ABBREVIATED PLAT AGENDA

July 3, 2024

**STAFF REVIEW AND RECOMMENDATIONS
PUBLIC HEARING
JULY 3, 2024**

PRELIMINARY PLAT: FRANKSLAGOON
LEGAL DESCRIPTION: SEC 21, T17N, R02W, SEWARD MERIDIAN AK
PETITIONERS: FRANCES FLOYD MERRIGAN, JR.
SURVEYOR/ENGINEER: BULL MOOSE SURVEYING
ACRES: 5.01 ± PARCELS: 2
REVIEWED BY: NATASHA HEINDEL CASE #: 2024-070

A PLAT OF
FRANKS LAGOON SUBDIVISION

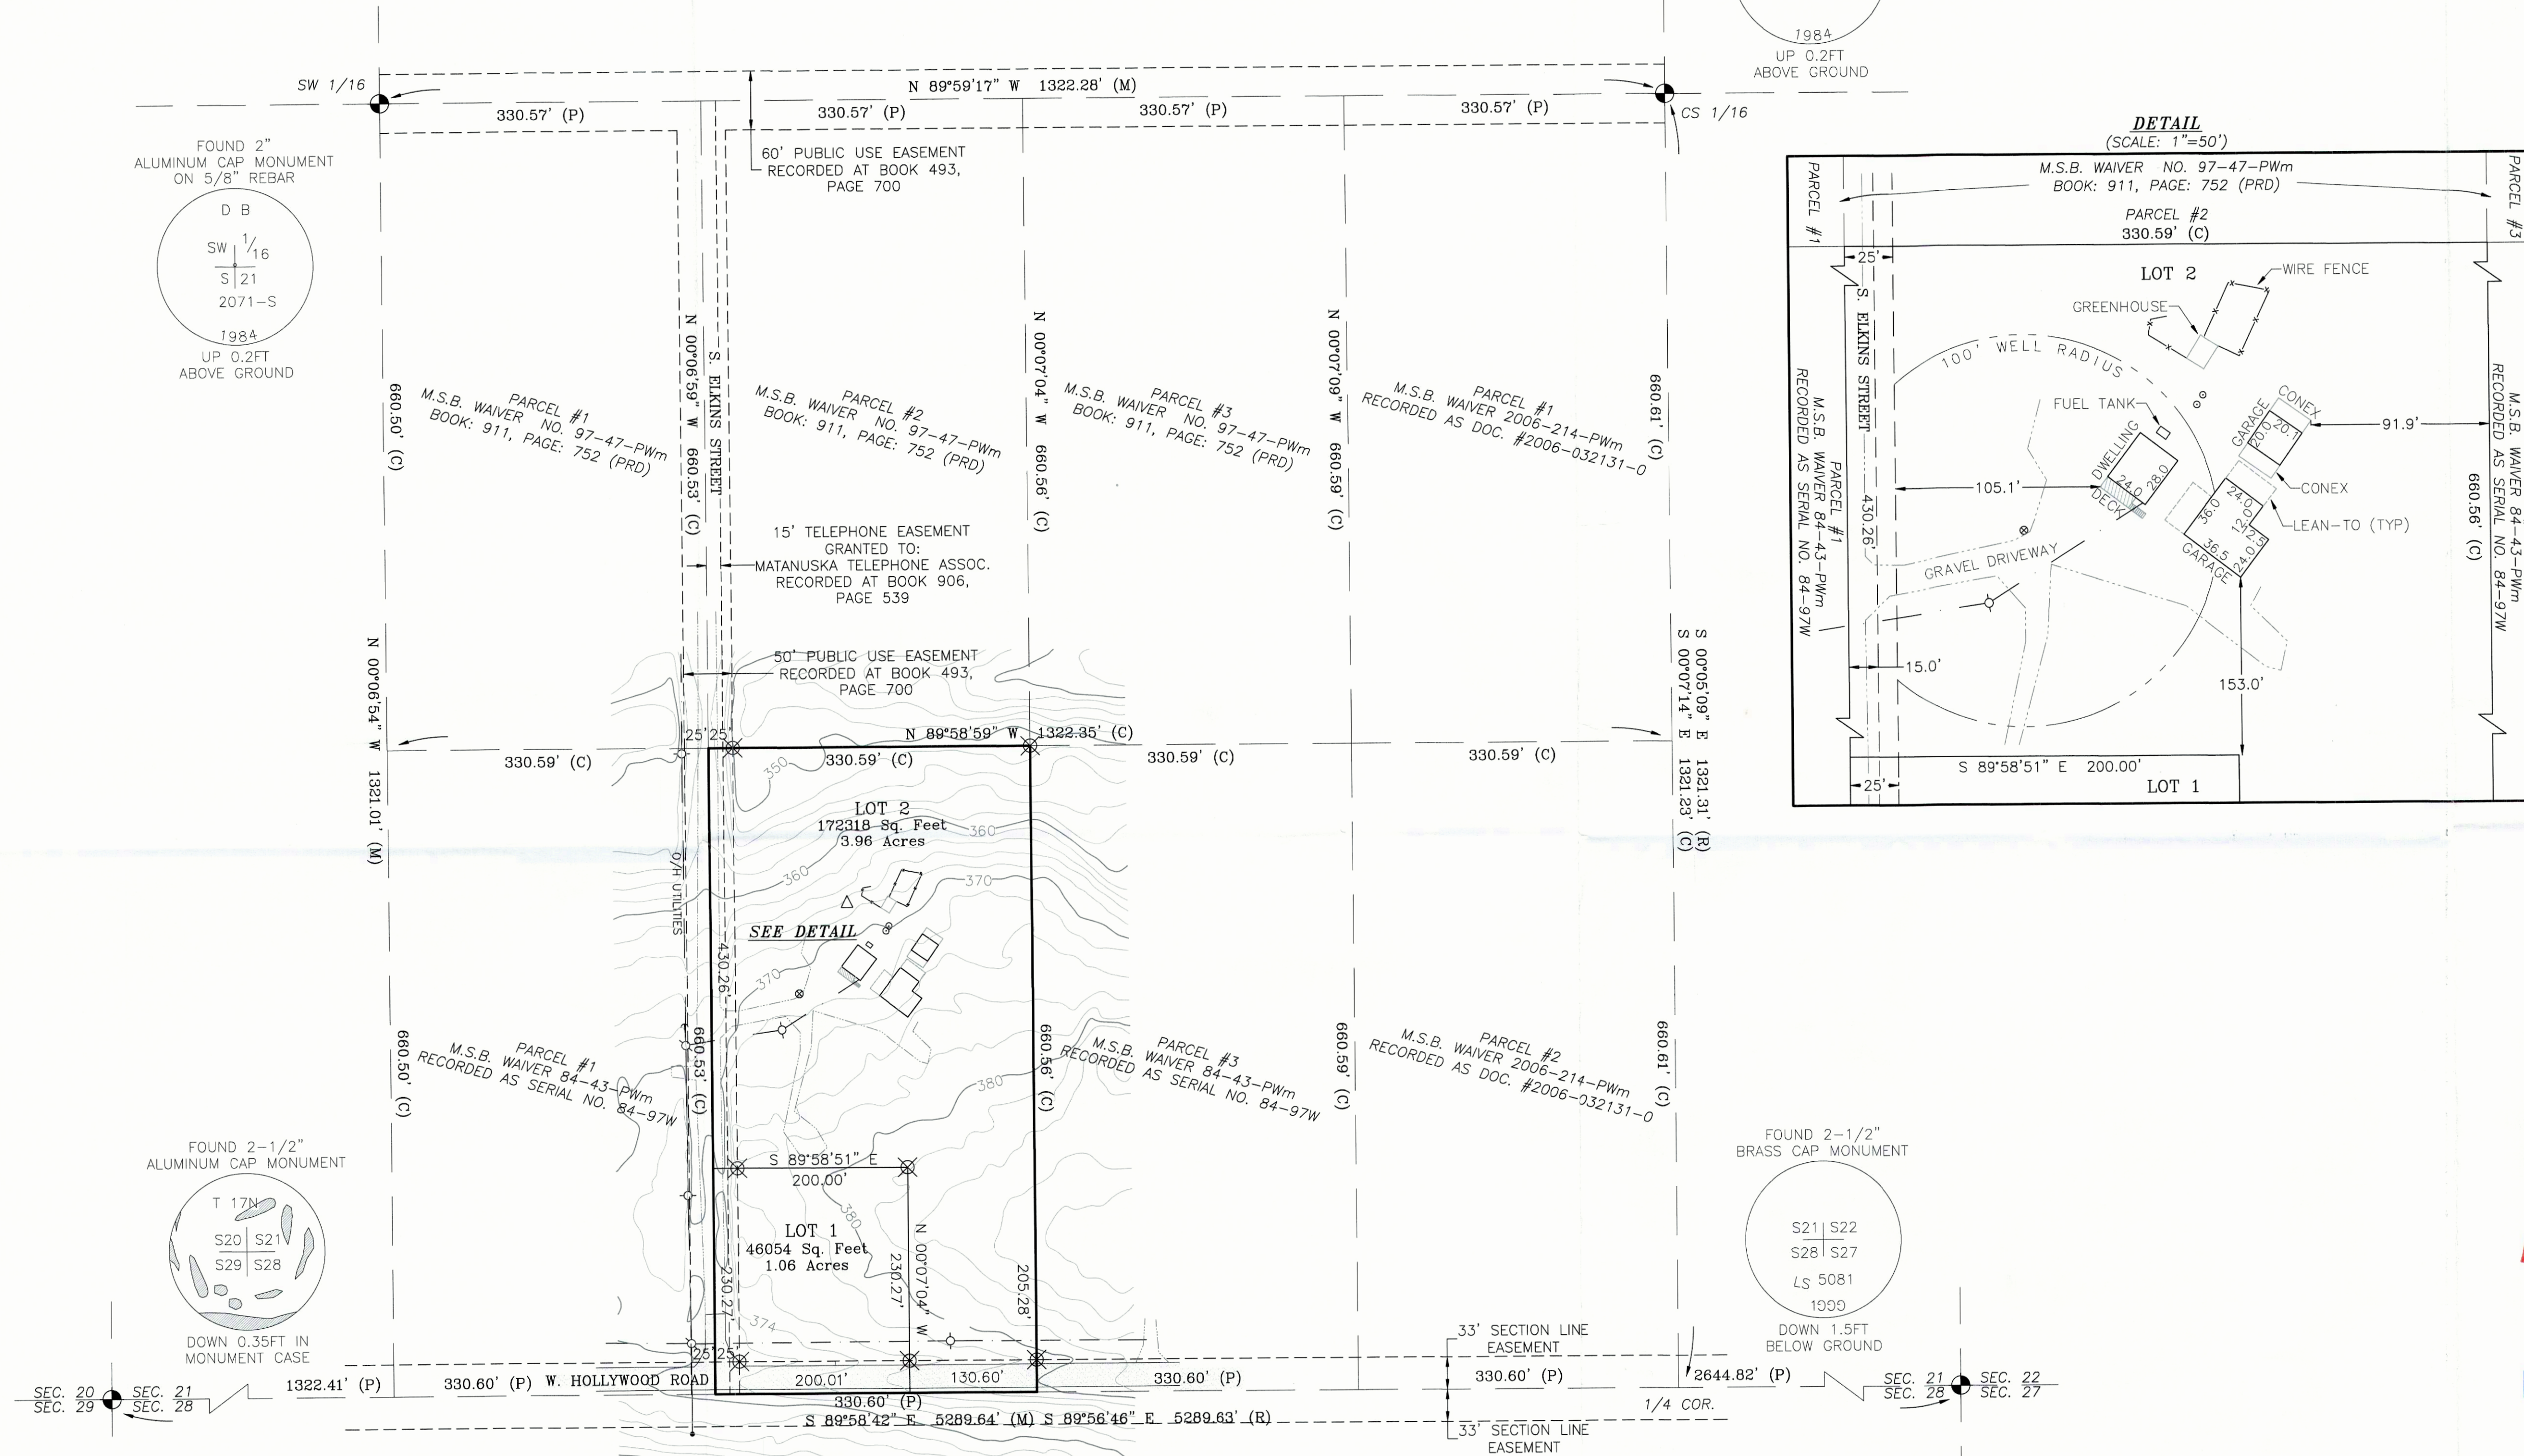
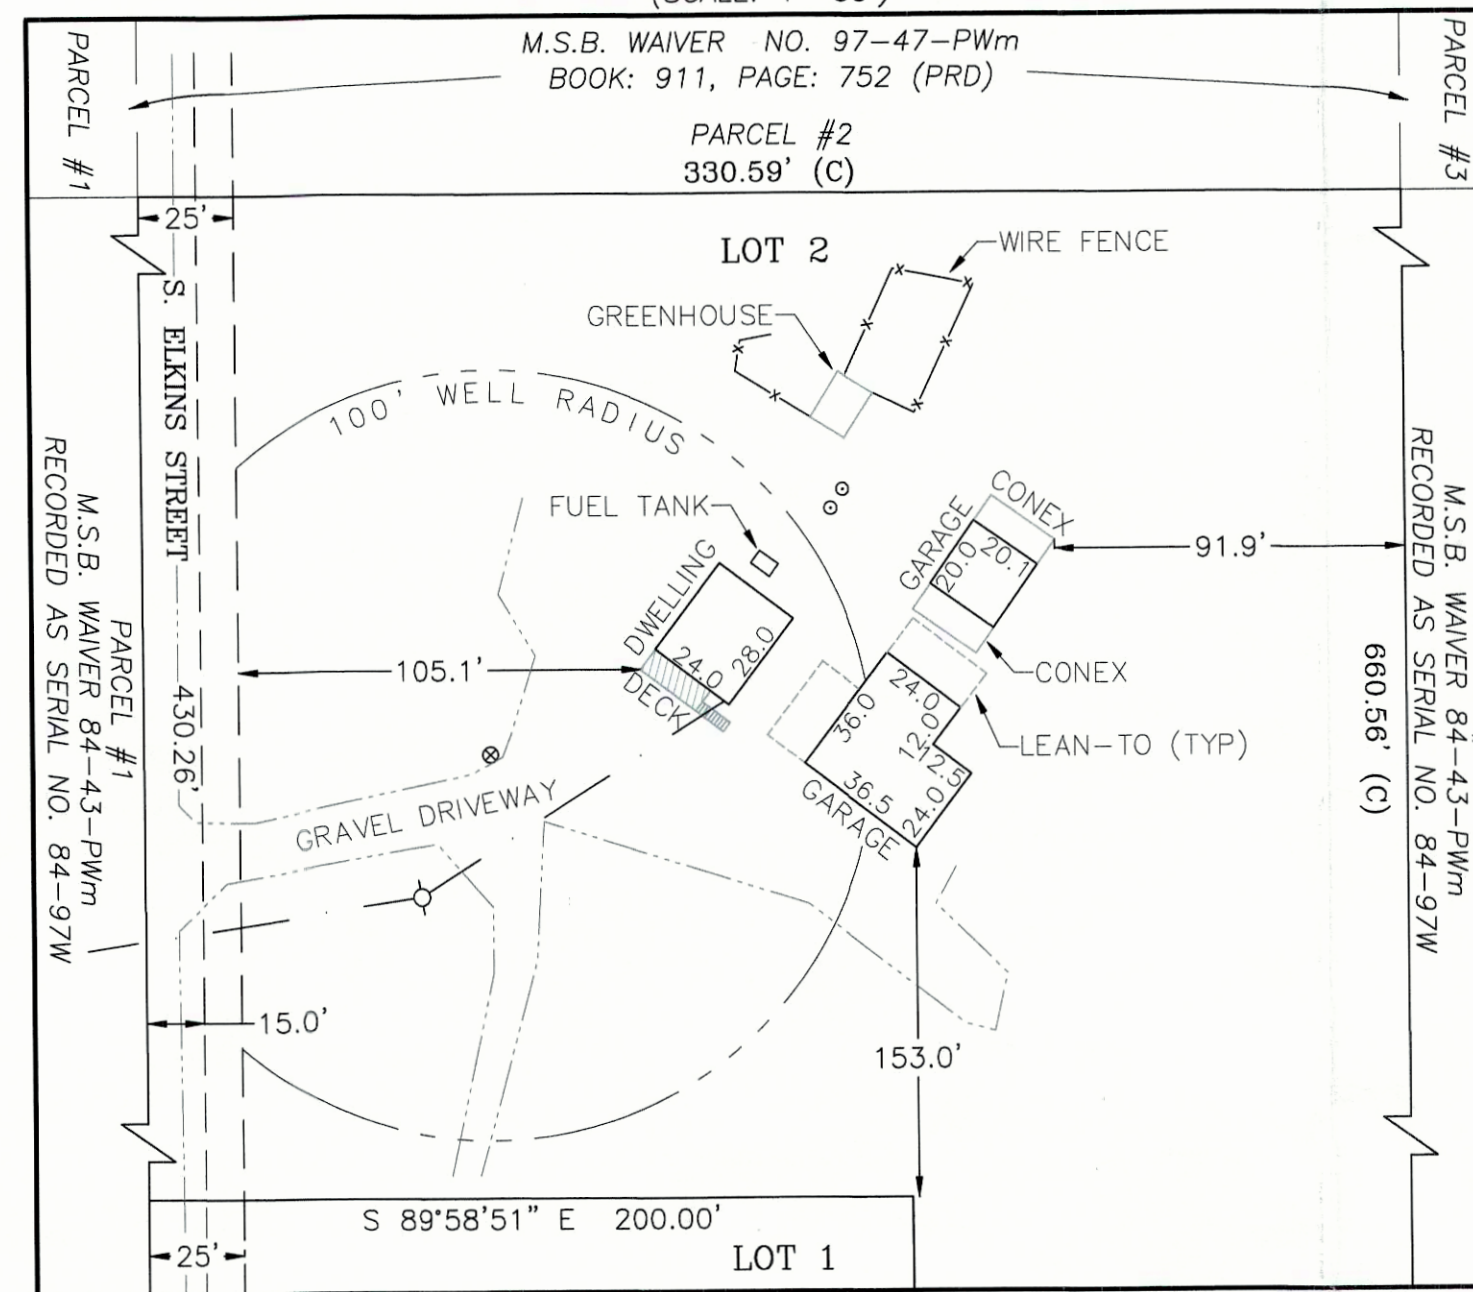
Comments: The State of Alaska Department of Transportation and Public Facilities (DOT&PF) (**Exhibit C**) notes that they do not have an objection to the lot subdivision. Both lots must take access through S. Elkins Street. Add as plat note: “No direct access for Lot 1 or Lot 2 to Hollywood Road” (*see recommendation #3*).

Utility companies (**Exhibit D**), Enstar and GCI, stated that they have no comments to the proposed plat. MTA requests a utility easement along the south boundary; the north 15’ of the south 48’ to create a utility easement adjacent to the section line easement (SLE). *Staff notes an abbreviated plat cannot grant utility easements. If the petitioner so chooses, they may grant the requested easement by document and the recorded information will be shown on the final plat.*

MSB Division of Assessments (**Exhibit E**) notes that the plat should show the property owner’s full name as they took title (*see recommendation #4*).

- **Franksagoon; Waiver Parcel #2, MSB Waiver 84-43-PWm recorded as 84-97w (Hollywood Road)**
 - No objection to lot subdivision.
 - Both lots must take access through S Elkins Street.

- Please add as plat note: "No direct access for Lot 1 or Lot 2 to Hollywood Road."
- **PA 11 Acutek for Johnson Ferris (MG); Plat #2016-134, Plat #10-39 (Old Glenn Highway)**

Although this is an abbreviated plat, the only comment MTA would like to add is a UE along the south boundary- the north 15' of the south 48' so we're adjacent to the SLE.

Francis Floyd Merrigan Jr. (per QD rec @ Bk 80 Pg 35 PRD) is listed on the Agenda plat as Francis Merrigan Jr., we should include his middle name on the plat as that is how he is in title so we don't have a hangup here in Assessments.

1. Taxes and special assessments must be paid in full for the year of recording, per MSB 43.15.053(F) and AS 40.15.020. Pay taxes and special assessments (LIDs) by certified funds or cash.
2. Provide updated Certificate to Plat executed within seven (7) days prior to recording and submit Beneficiary Affidavit for any holders of a beneficial interest, if any.
3. Add plat note to read: "No direct access for Lot 1 or Lot 2 to Hollywood Road".
4. Correct plat to include the property owner's full name as they took title; Francis Floyd Merrigan Jr.
5. Pay postage and advertising fees.
6. Show all easements of record on final plat.
7. Submit recording fees, payable to Department of Natural Resources (DNR).
8. Submit final plat in full compliance with Title 43.
